Re: Request for Time Extension – New Construction of a Single-Family Home
Located at Approximately 757 N. Wall Street
Petitions PLNHLC2014-00628 & 00730

Re: Petitions PLNHLC2014-000730 & PLNHLC2014-00628
New Single-Family Home at approximately 757 N. Wall Street

New Single Family Dwelling New Construction PLNHLC2014-00730 and PLNHLC2014-00628 757 North Wall Street

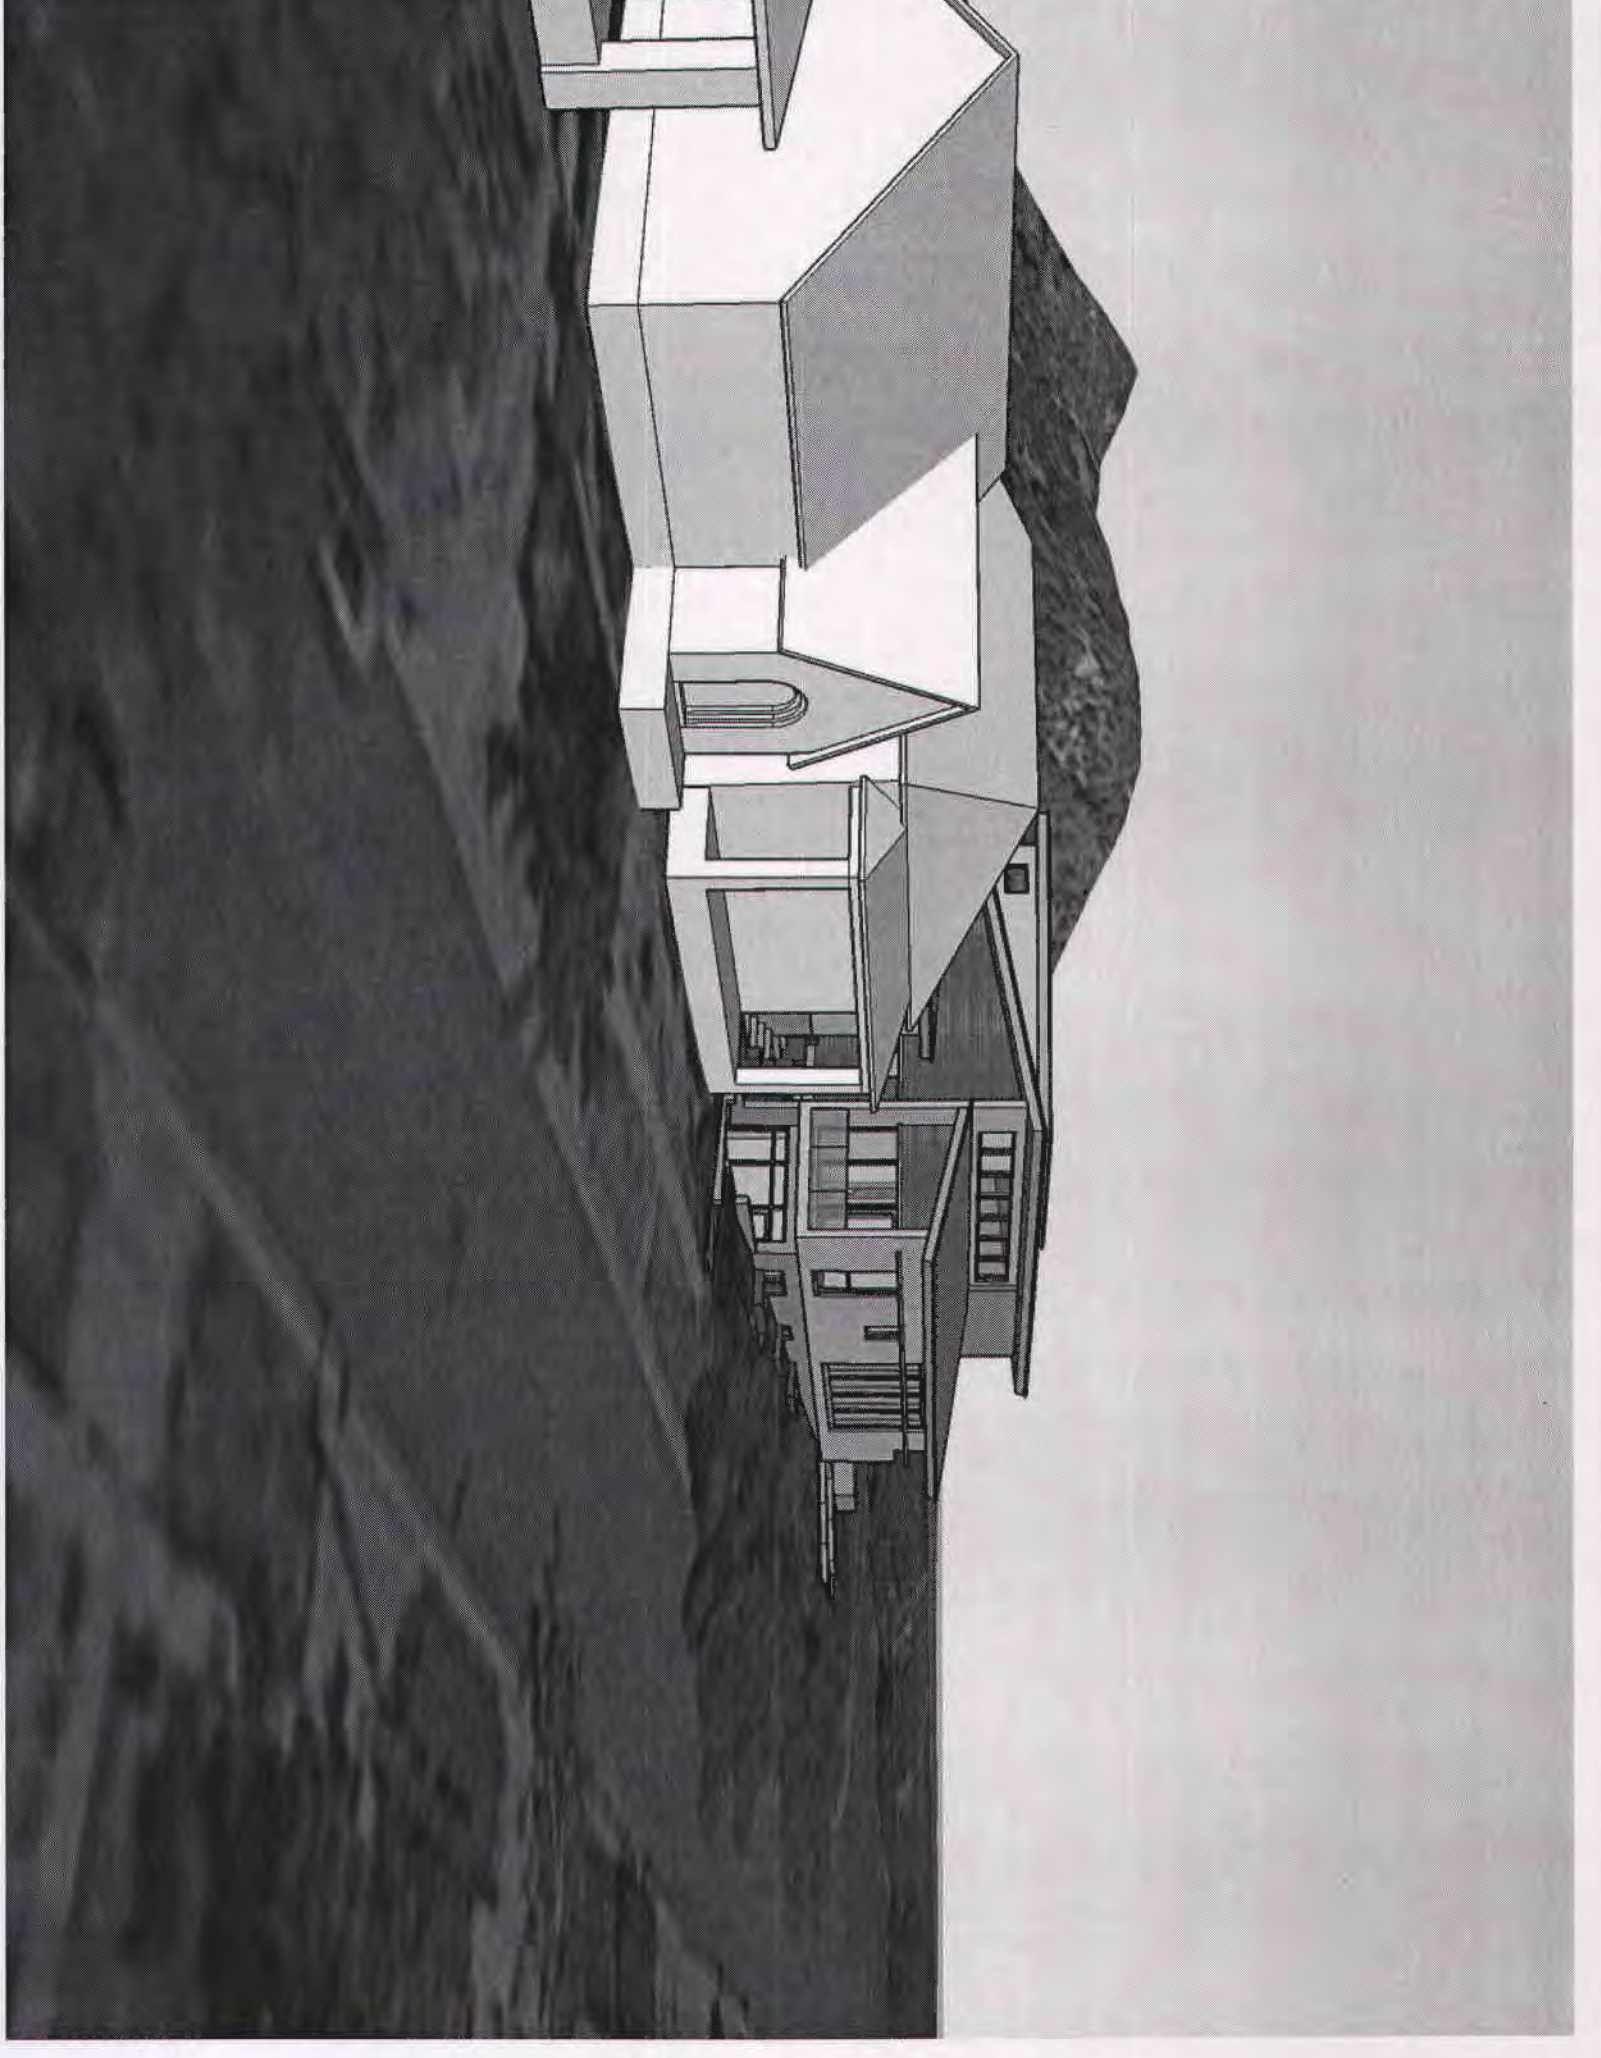
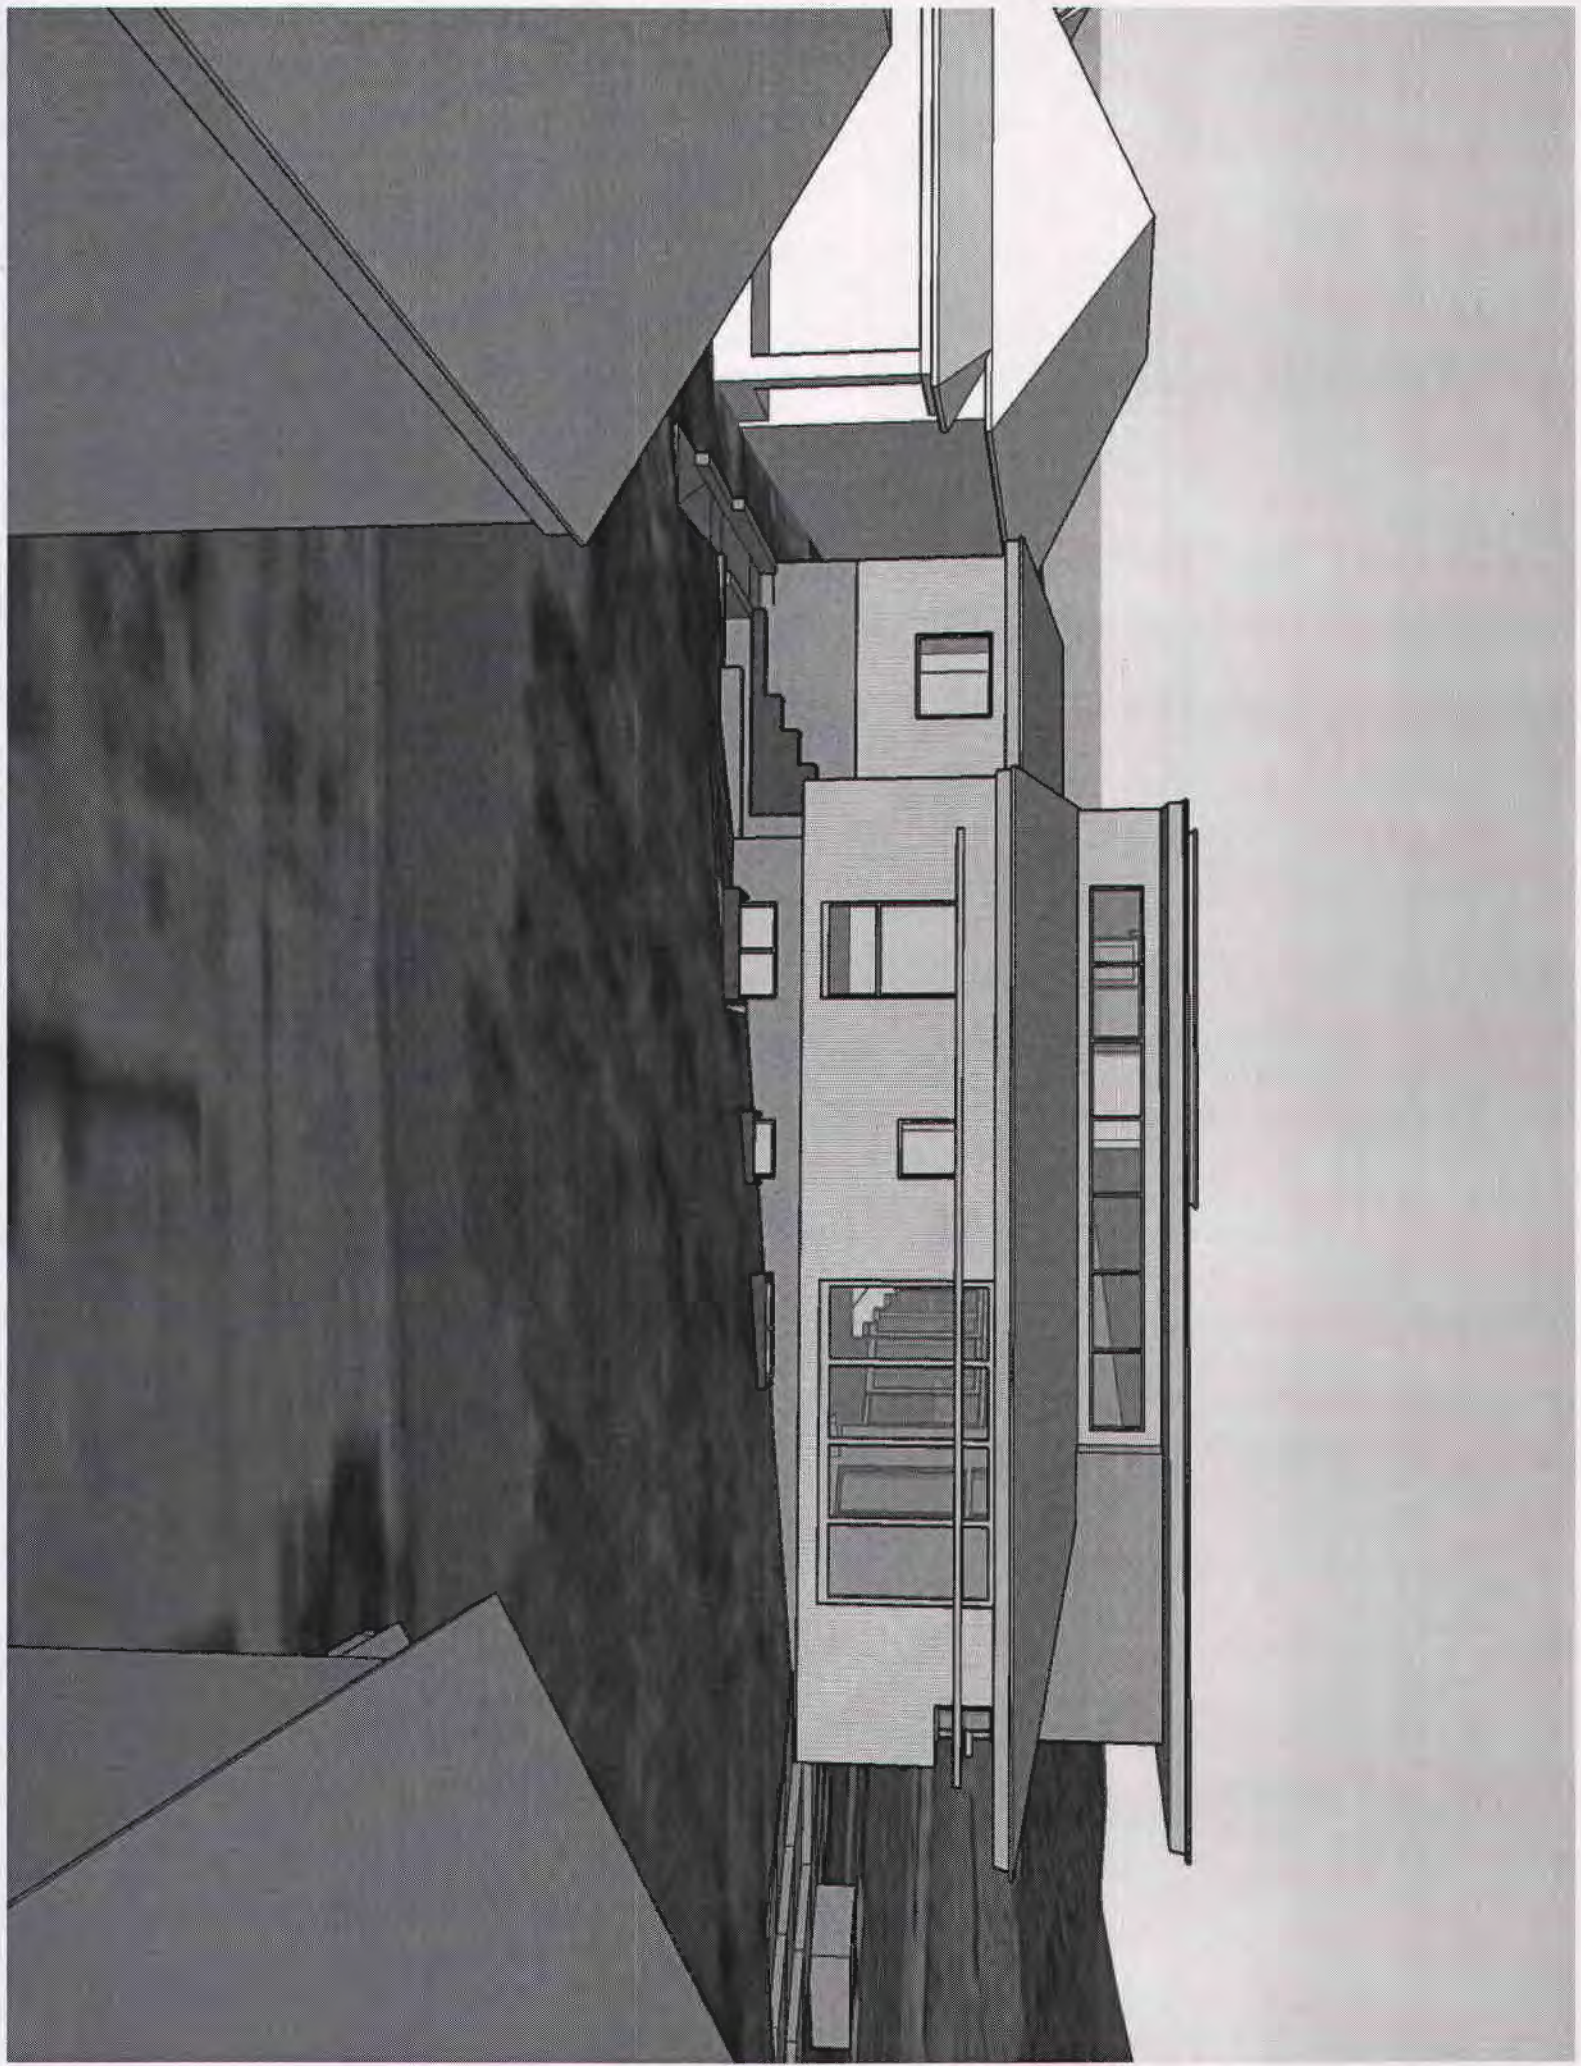
The applicant presented revised plans for the proposed home addressing the subcommittee's concerns from the prior meeting. The revised schematic drawings are attached.

A question was raised regarding a possible trellis structure on the Wall Street façade. The applicant indicated that natural landscaping was preferred to a structure.

The commissioners agreed that the revisions were positive and that the project was ready to be evaluated by the entire HLC once again.
